Product Change Notification

1. ECR #: 173451
Notification #: 429

- LPAM - LPAM TERMINAL ARRAY ASSEMBLY

5. Description of Change:
Changes to SMT-side pin geometry

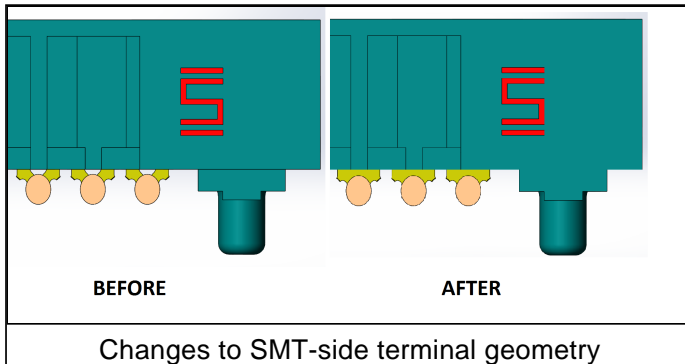
7. Reason for Change:
In an effort to continually improve products, Samtec has revised LPAM pin geometry. All changes are backwards compatible with existing LPAX. Orders may contain connectors with and without these modifications until inventory is depleted. The void above the solder crimp on the SMT-side of the terminal was removed to improve visual consistency of the solder-joint when inspected by X-ray.

- Form - SMT-side terminal geometry will have a small void removed, just above the solder crimp
- Fit - Changes are backwards compatible with all existing LPAX; no change to overall size or footprint
- Function - The anti-wicking laser-score capability was improved to include all sides of the stamped pin
